Optimization Review
Ogallala Ground Water Contamination Superfund Site
Operable Unit 2 (Tip Top Cleaners)

OPTIMIZATION REVIEW

Report of the Optimization Review
Site Visit Conducted at the Ogallala Ground Water Contamination Superfund Site, OU2, on
24 July 2012

Final
16 January 2013

Figure 1. Site Location and April 2012 PCE Plume

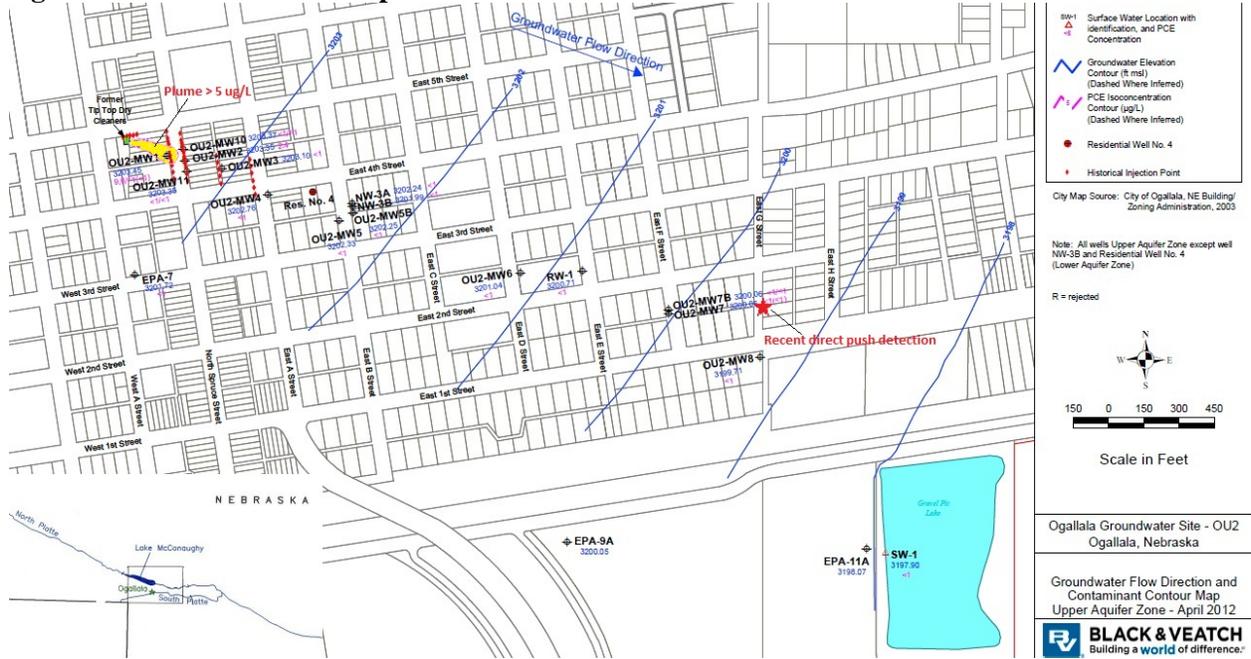
Figure 1 shows the most recent ground water contaminant plume (April 2012). Ground water contamination is essentially limited to PCE. Limited detections of TCE have been observed, generally below the MCL of 5 micrograms per liter (ug/L). PCE concentrations have been as high as 1,200 ug/L in OU2-MW-2, and concentrations in the 100s of ug/L extended to OU2-MW-7 in the early 2000s. Concentrations had exceeded the 5 ug/L PCE clean-up level in

A recent (within the past year) direct-push sampling location just north of OU2-MW-8 at the inferred downstream end of the OU2 plume had PCE detections greater than 30 ug/L.

The recent detection of 10s of ug/L of PCE in a direct-push sample north of OU-MW-8 raises a question of the definition of the plume. The persistent PCE concentrations in ground water just downgradient of the former Tip Top Cleaners site also suggest that one of the following influences may still be serving as a source of PCE mass flux to ground water: there may still be diffusion-limited mass-flux (i.e., matrix diffusion) originating from the source area or immobilized within finer-grained aquifer soil units; or more than a minimal level of residual mass still remains immobilized within the top of the source area saturated zone that continues to dissolve into ground water flow. Either of these potential PCE mass scenarios could continue to impact ground water quality in the absence of additional reactive permanganate.

The extent of the plume downgradient of East G Street has not been determined. Even though there may not be complete exposure pathways to the east-southeast, the plume is not currently fully defined and it cannot be assured that no exposure exists. This plume delineation data gap primarily applies to the intermediate and deeper zones of the shallow aquifer unit between a depth of approximately 30 and 65 ft bgs. The existing monitoring network appears to have delineated the upper portion of the shallow aquifer unit to a depth of approximately 30 ft bgs. Monitoring wells MW-10 and MW-11 provide data concerning the north and south edges of the plume at downgradient locations near the source area.

Upcoming planned assessment activities recently communicated by the Project Team include vertical profiling and plume delineation in the area of monitoring well MW-8 using a combination of various direct-push techniques such as membrane interface probe ([MIP], soil gas measurements), electrical conductivity ([EC], mapping tool for soil types), hydraulic profiling tool ([HPT], which measures formation permeability for preferential migration pathway identification), and soil/groundwater grab sampling. The field data collection using these direct-push techniques will be used to identify locations for the installation of additional nested monitoring wells within the intermediate and deeper depths of the shallow aquifer unit.

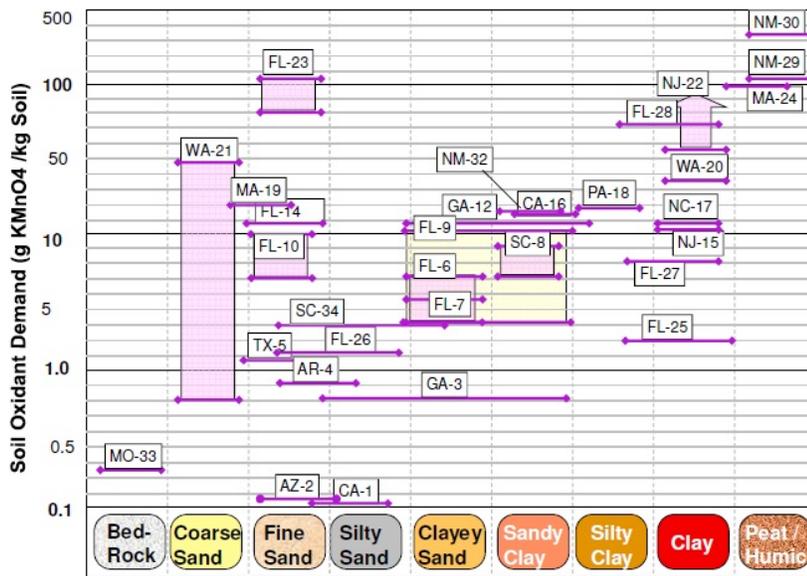
The implemented remedy appears at face value to have been largely successful as the downgradient PCE groundwater concentrations have dropped significantly. See Figure 2 for graphs of the concentrations over time in selected monitoring wells. In order to verify the success of the program, some data gaps need to be addressed, however.
